MEETING NOTES

East Bayfront Transit Environmental Assessment

EBF Community Liaison Committee Meeting #2 **PURPOSE:**

East Bayfront Transit EA - CLC #2 January 22, 2007

Development of Lakeshore and Queens Quay Bus Options in more detail

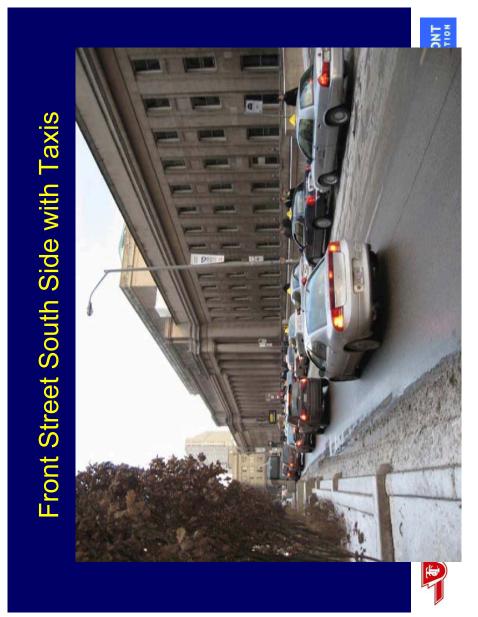
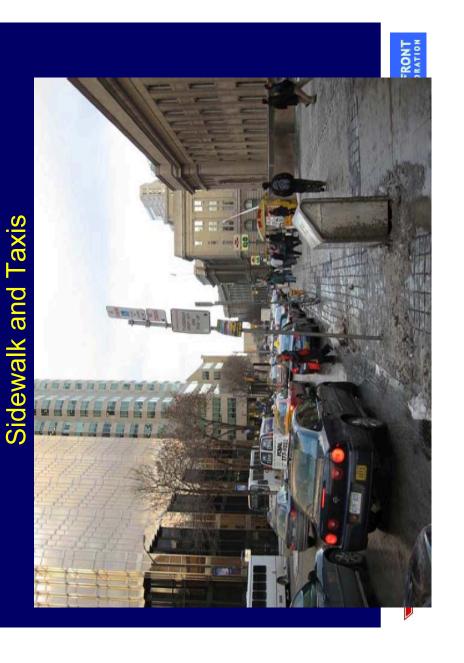
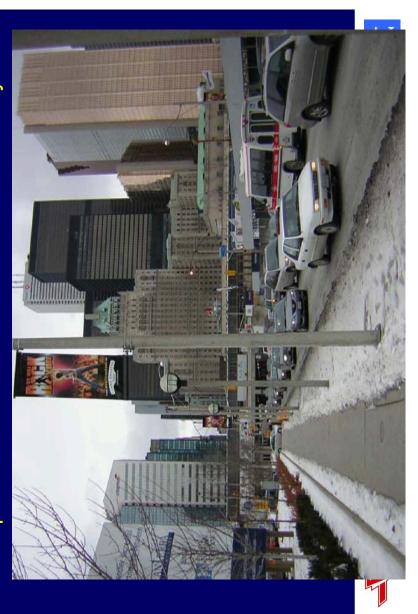
- b) D. Callan presented a preliminary concept of a 'surface transit' scheme for both the 'Queens Quay Only' and 'Lake Shore Express plus Queens Quay Local' options. 'Queens Quay' buses would access Union Station via bus-only lane on Bay Street, Lake Shore Boulevard, York Street, and Front Street. 'Lake Shore' buses would access Union Station via bus-only lane on Lake Shore Boulevard, York Street, and Front Street. Both corridors would complete their loop via southbound Bay Street. One or two traffic lanes would be converted to bus-only lane(s). The existing taxi stand in front of Union Station would have to be relocated.

- c) **CLC:** Is Front Street the only option for buses to unload passengers at Union Station? How about Bay Street?
- d) **ST:** Front Street is the best option though it is not the only option. The issue with Bay Street is that there is not enough frontage south of Front Street for multiple number of articulated buses to load/unload passengers.

- e) **CLC:** The Lake Shore Express as shown on your drawing does not run straight through Lake Shore Boulevard?
- f) ST: Within the scope of this study, the Lake Shore Express is meant to serve future demands in the Port Lands. It certainly does not preclude any future east-west transit route on Lake Shore Boulevard that may potentially connect the east end of Toronto with the west end.

- g) D. Callan explained why the 'surface transit' scheme would require

two traffic lanes on Front Street: the curb lane (currently the taxi stand) is needed for installing multiple bus bays; the lane adjacent to the taxi stand is needed as a passing lane for buses pulling in and out of the bus bays. The Study Team assumes that this 'surface transit' scheme may be feasible – more work will be done to define this scheme further.

Ridership Volumes on Bay Street

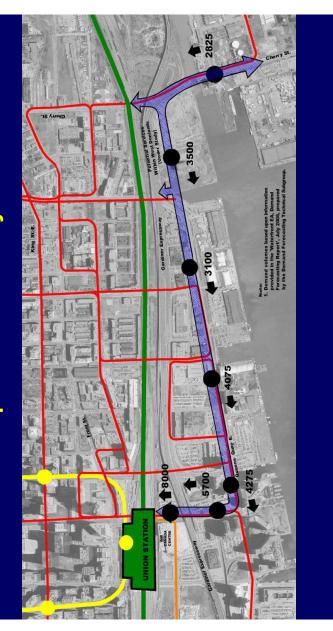
- 1) **CLC:** The 8000 passengers arriving at Union Station where will these people come from?
- m) **ST:** The 8000 passengers is a forecast figure that includes existing and future transit users from the Queens Quay West streetcar, the future Queens Quay East transit line, and the possible future Bremner Boulevard streetcar line. The figure assumes a full build-out, full development plan in the entire Central Waterfront.

- r) **CLC:** Your demand forecast shows that there will be 3700 transit users entering Union Station from Bremner Boulevard but people who live there will walk to Union Station instead of taking transit.

- s) **ST:** That figure includes future transit users coming from areas west of Spadina Avenue. These users would be heading to Union Station via a possible future Bremner streetcar line.

TTC Feasibility Plan for Underground Station

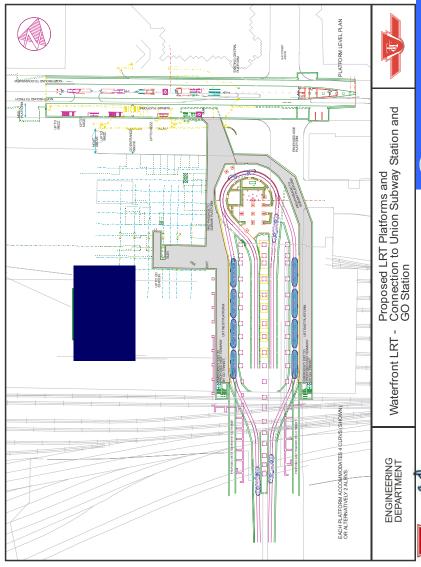
- a) This is a technically feasible plan from an engineering/structural point of view. In essence, this is an expanded loop with 4 'legs' (tracks).
- b) In this EA, the Study Team will look at the feasibility of expanding the loop.

- c) This expansion plan has been designed to handle streetcars operating under 2-minute headways from Queens Quay West and Queens Quay East, i.e. a combination of one streetcar every minute.

- d) A Queens Quay East streetcar entering the loop will follow the new inbound track to load/unload passengers at the east platform. This streetcar will then proceed around the loop and use the existing outbound track to re-enter the tunnel.

- e) A Queens Quay West streetcar entering the loop will follow the existing inbound track that leads the vehicle around the loop into the new outbound track where the streetcar will load/unload passengers at the west platform. This streetcar will then proceed along the new outbound track and re-enter the tunnel.

- f) As shown in the plan, passengers coming off the streetcars will follow a 'fare-paid' passageway to the expanded subway platform at Union Station. Transfer between streetcar and subway will be seamless as the connection will take place on the same level, i.e. passengers coming off the streetcar will not have to climb up stairs and then go down an escalator to reach the subway, and vice versa.

- g) This loop expansion plan can be implemented by stage. At the initial stage we can build only the west platform and the new outbound track. In the space between the new and existing outbound tracks, an interim east platform can be built to load/unload passengers on the Queens Quay East streetcars as well as to facilitate transfer between East and West streetcars. The east platform and the new inbound track can be constructed at a later stage.

- ST: A potential Lake Shore Express serving the Port Lands would be a 'surface bus option' that follows the scheme presented to you earlier tonight.
- m) **CLC:** Your loop expansion plan shows 4 LRVs at each platform. Since we are talking about streetcars, if the vehicle in front is running slow for some reason, the vehicles behind will not be able to pull out and bypass the slow vehicle. How will that affect the whole operation of this loop?

- n) **ST:** We showed 4 LRVs in this drawing to illustrate how long each new platform can be. Yes, an inherent limitation to streetcars is that they cannot bypass one another on the same track.
